**DOMINION NUCLEAR CONNECTICUT, INC.**  
**VIRGINIA ELECTRIC AND POWER COMPANY**  
**MILLSTONE POWER STATION UNIT 3**  
**NORTH ANNA POWER STATION UNITS 1 AND 2**  
**SURRY POWER STATION UNITS 1 AND 2**  
**SUBMITTAL OF TOPICAL REPORT VEP-NE-1-A REVISION 0, MINOR**  
**REVISION 3, RELAXED POWER DISTRIBUTION CONTROL METHODOLOGY**  
**AND ASSOCIATED FQ SURVEILLANCE TECHNICAL SPECIFICATIONS**  
**AND TOPICAL REPORT VEP-FRD-42-A, REVISION 2, MINOR REVISION 2,**  
**RELOAD NUCLEAR DESIGN METHODOLOGY**  
**FOR INFORMATION ONLY**

Enclosed is one copy of topical report VEP-NE-1-A, Revision 0, Minor Revision 3, "Relaxed Power Distribution Control Methodology and Associated FQ Surveillance Technical Specifications," and one copy of VEP-FRD-42-A, Revision 2, Minor Revision 2, "Reload Nuclear Design Methodology."

Submittal of VEP-NE-1-A, Rev. 0, MRev. 3 and VEP-FRD-42-A Rev. 2, MRev. 2 for Info. Only

DELTA-I POINTS VS POWER LEVEL FOR S2C8 RPOC ANALYSIS

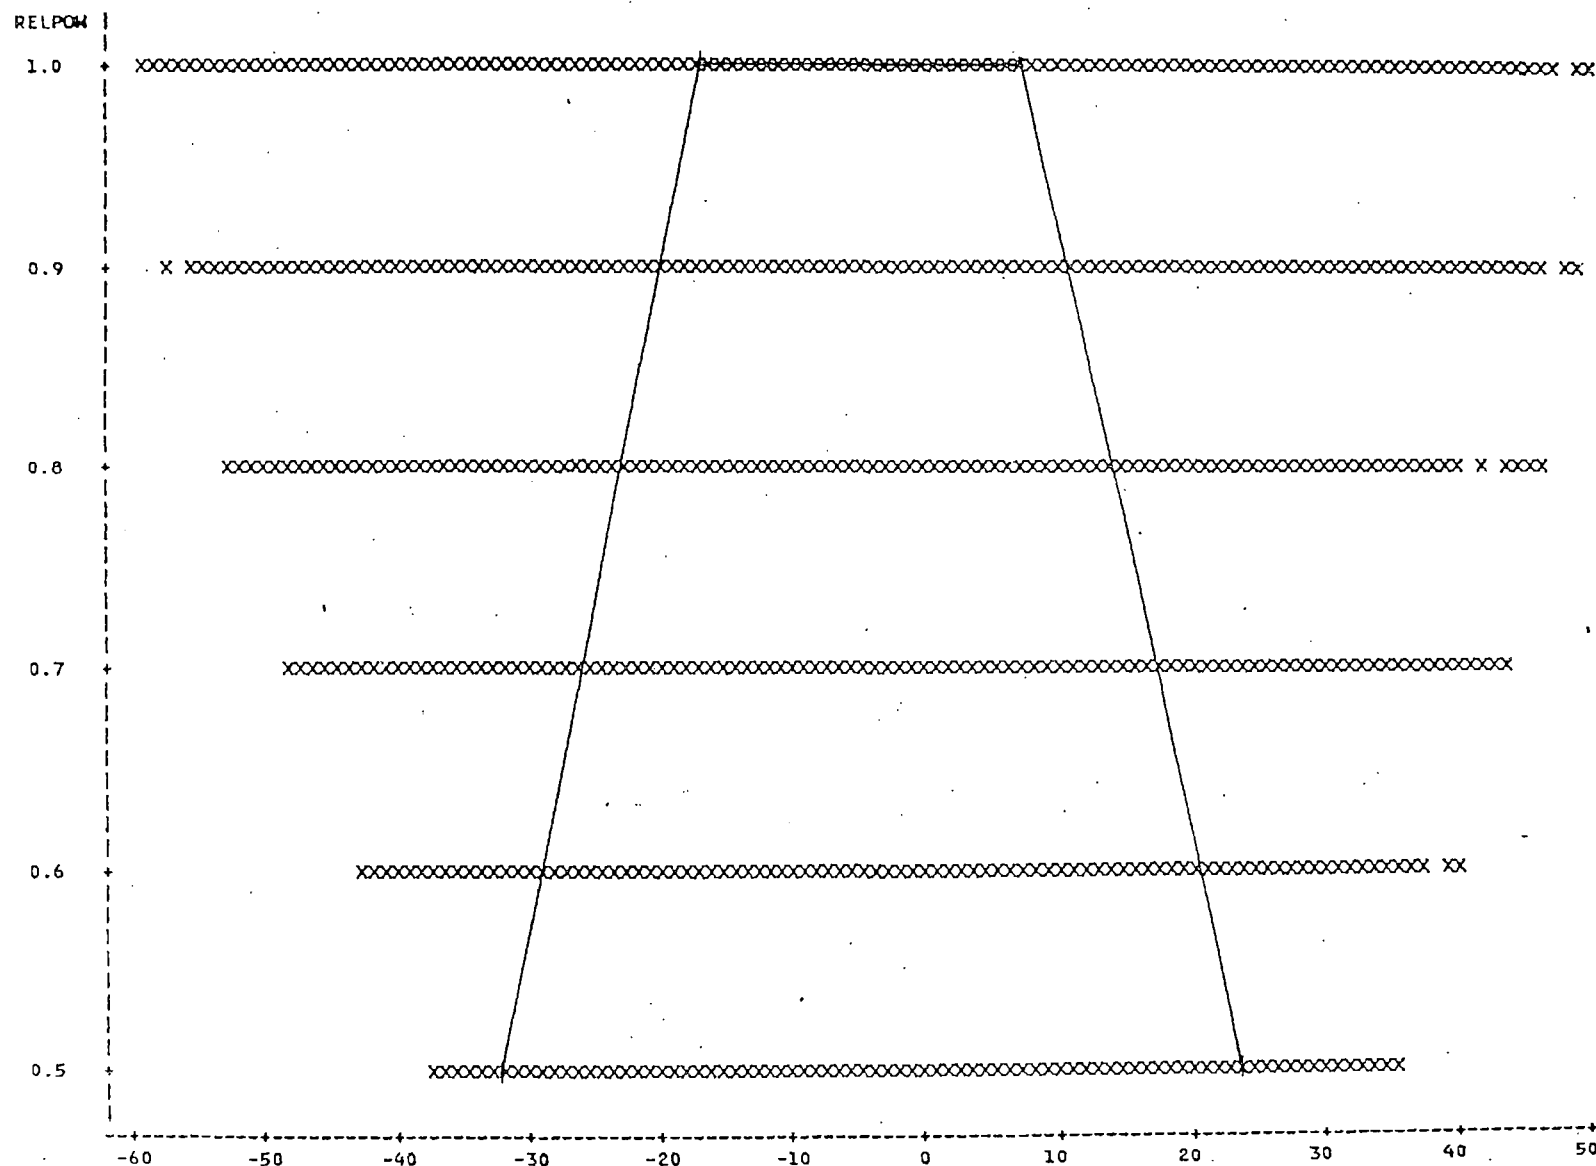
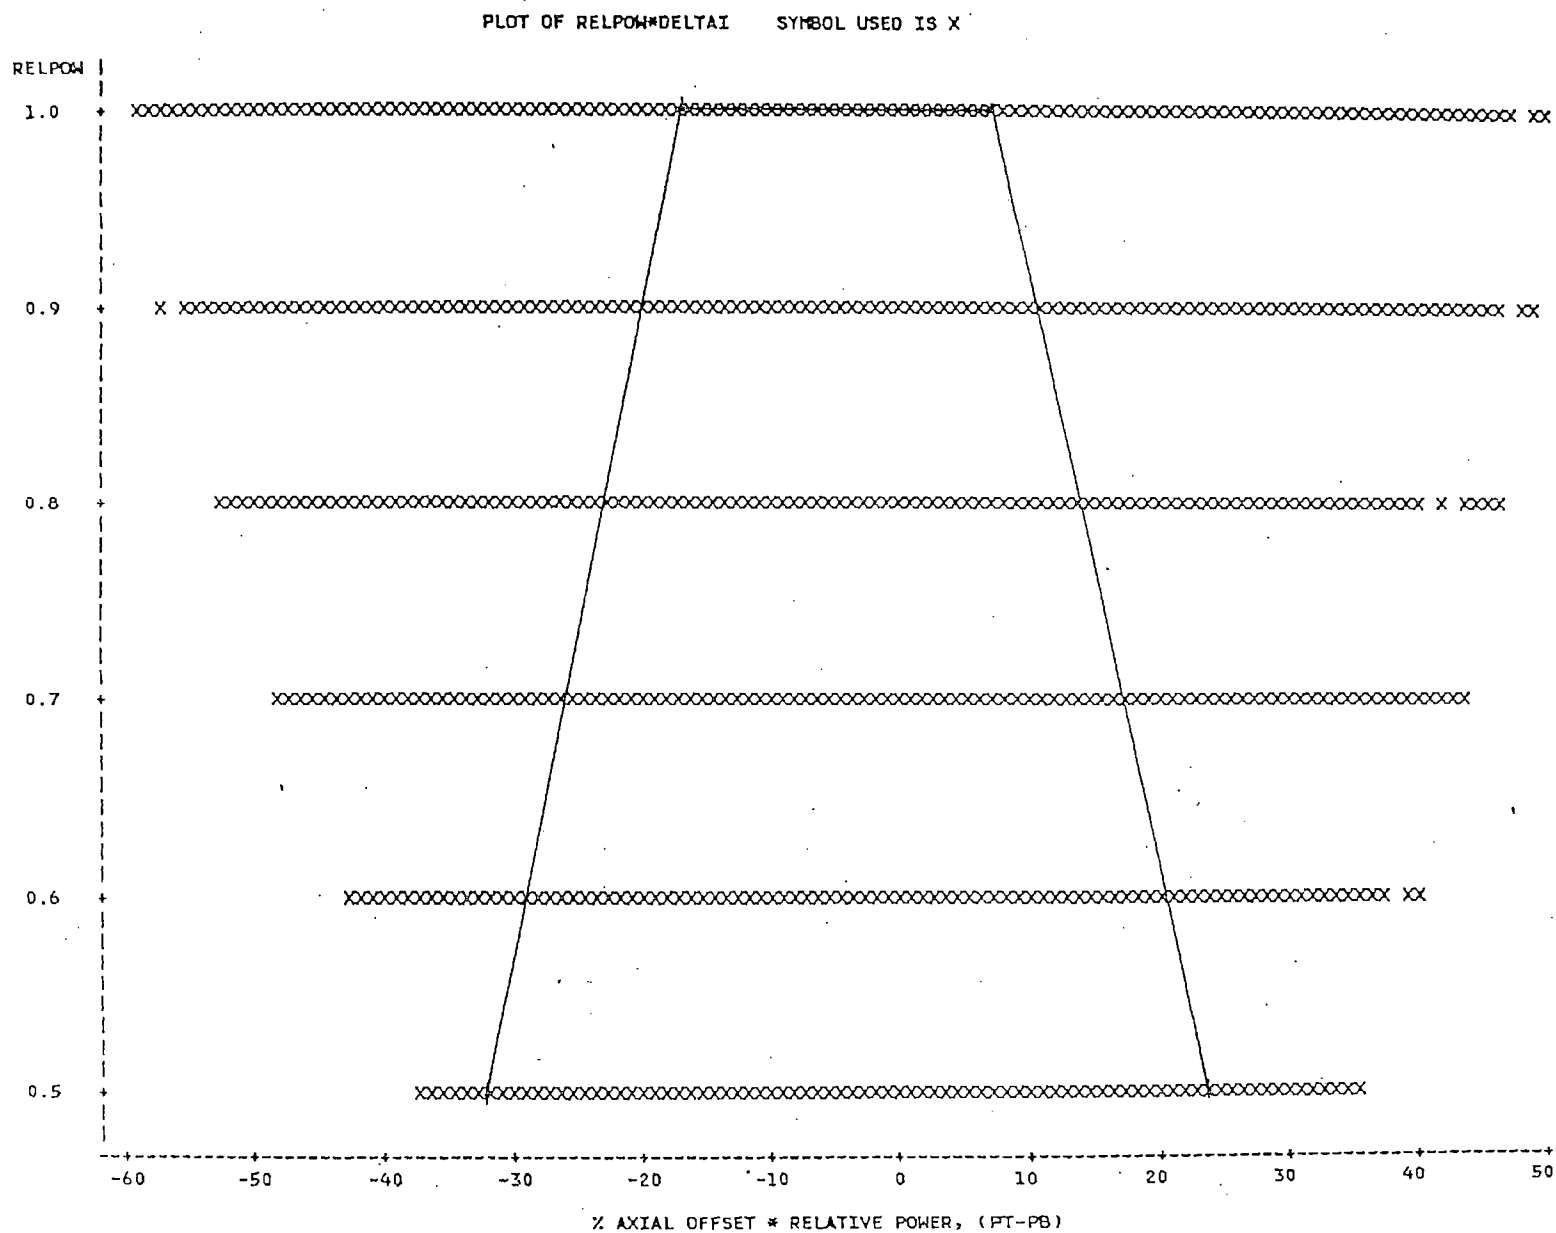
These xenon distributions, when combined with the power levels and rod configurations outlined in VEP-NE-1 (Reference 1), produce approximately 9000 power distributions which have a range of delta-I values significantly greater than the allowable delta-I operating space as shown in Figure 1. Note that at 50% power, a delta-I of  $-40\%$  is possible only if 90% of the core power is produced in the bottom half of the core. Figures 2 and 3 present histograms of the delta-I values calculated for a sample RPDC analysis. The histogram in Figure 2 includes all the delta-I values calculated regardless of power level while Figure 3 provides a histogram of the delta-I values generated corresponding to a specific power level (80% power in this case).

Figure 4  
RADIAL XENON REDISTRIBUTION FACTOR  $X_e(Z)$

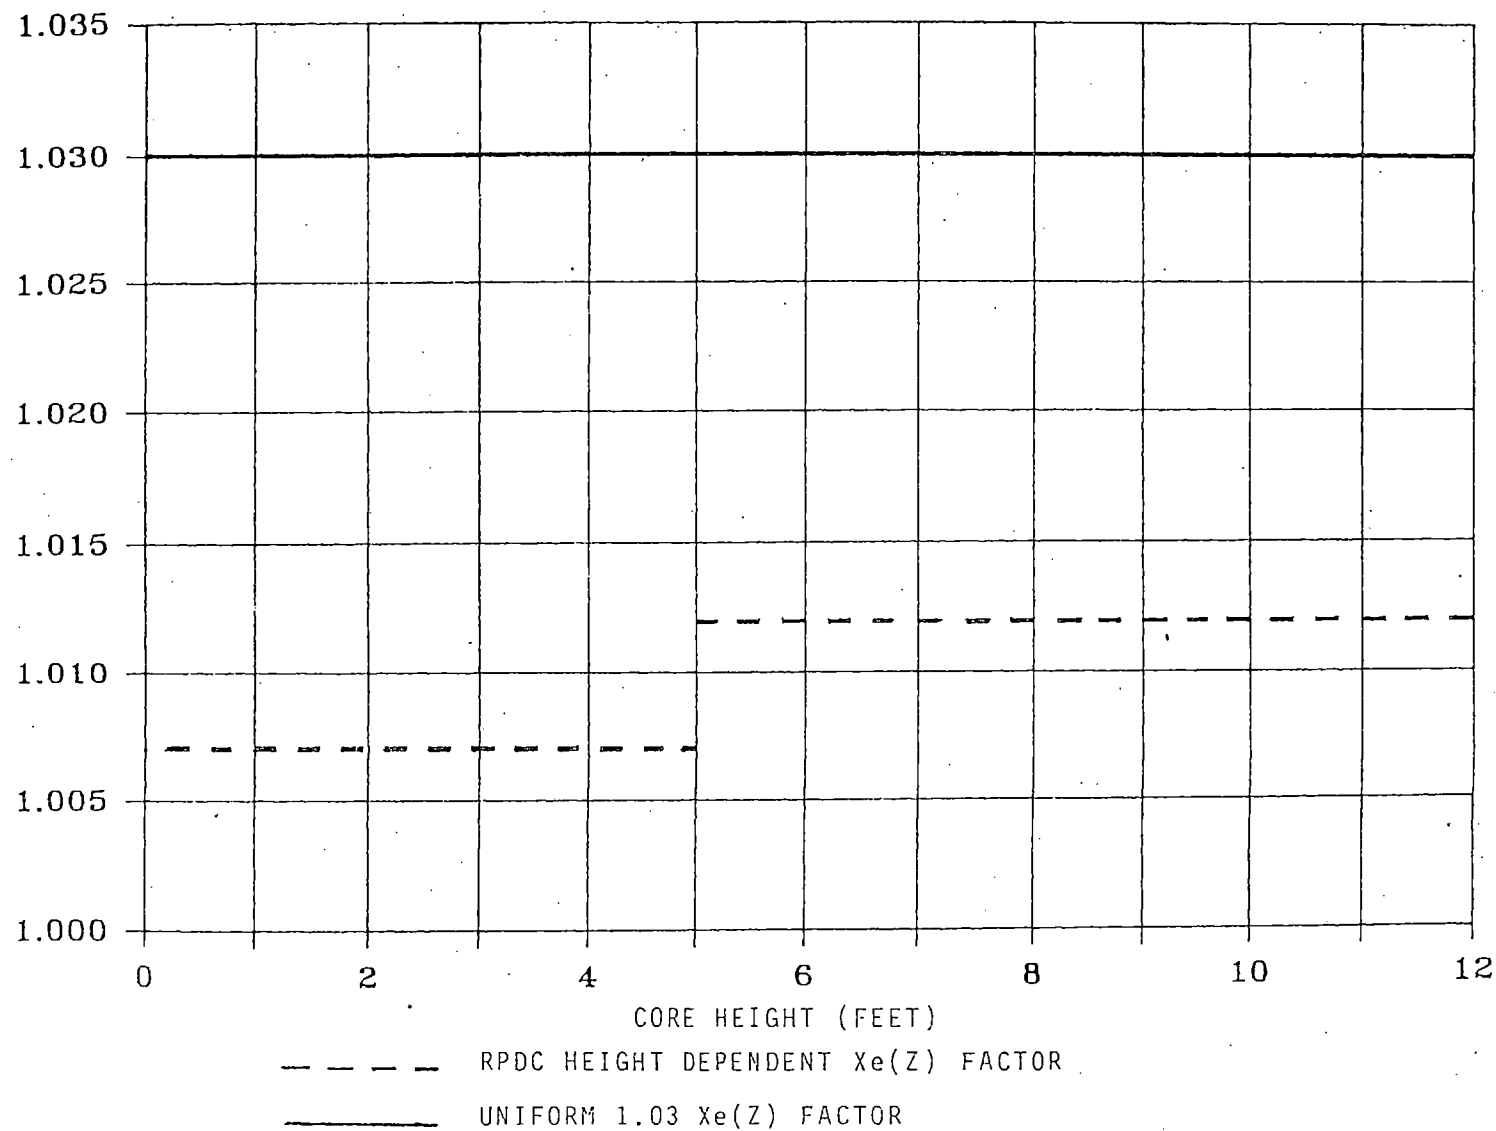
previous value of 1.03 which had been calculated using a 2-D model. As would be expected, the increase in  $F_{xy}(z)$  due to xenon redistribution showed the greatest sensitivity to the amount of control rod insertion during the precondition phase of the analysis as the control rods cause significant changes in the radial power distribution.

N1C16 HZP BOC B-Bank Differential Worth

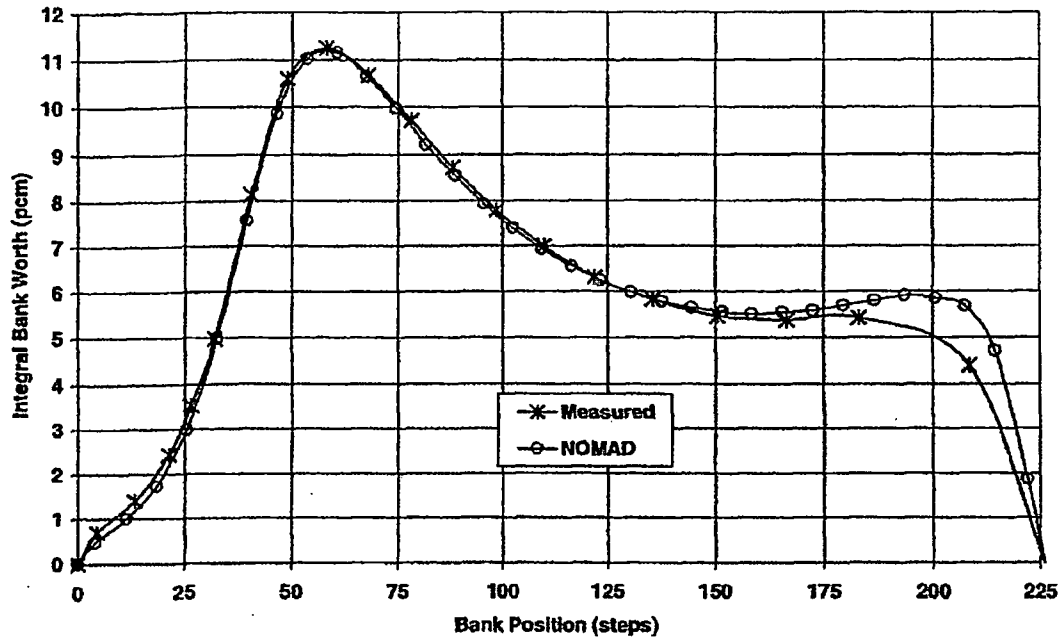
By letter dated December 2, 2002, VEP-1 stated that the accuracy of the NOMAD model is verified each cycle during startup physics testing and during routine core follow. Please provide representative results from a recent refueling outage (comparisons between the startup physics test data and the NOMAD predictions) that demonstrate the accuracy of this model.

Parameter	Measured	Predicted	Difference	Nuclear Reliability Factor
Critical Boron Concentration (HFP, ARO, EQ XE) ppm	1405	1429	24	±50 ppm
HFP ARO EQ XE Axial Offset	-2.5	-3.0	-0.5%	N/A
